ASOS MAINTENANCE NOTE 21 (for Electronics Technicians)

Autobalance Module Threshold Resistor (R5)

FIGURE 1

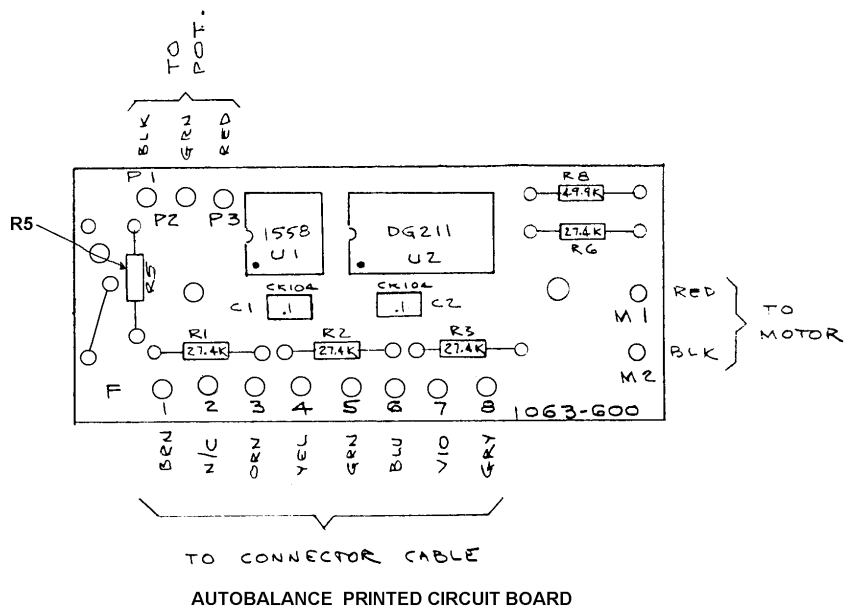
- A. On the next trip to each site, inspect the resistor R5 for its value. Reference the autobalance printed circuit Figure 1 for location of R5. Use the ASOS Site Technical

Manual (STM), Table 5.5.13 for the autobalance module removal and Figure 1 for location of R5.

- B. The resistor is marked with the resistance value. If marked with 2003xx, the value is a 200K ohm resistor and is correct. If the resistor is positioned so that the resistance value is not visible, use a multi meter to determine the value. A resistance reading close to 200K ohms is correct. A reading closer to 249K ohms is incorrect.

- C. If it is determined that the correct R5 resistor is installed, reinstall the autobalance module following the ASOS STM, Table 5.5.13.
- D. If it is determined that the incorrect R5 resistor is installed, return the autobalance module to NLSC and replace with the correct module as described in the ASOS STM.
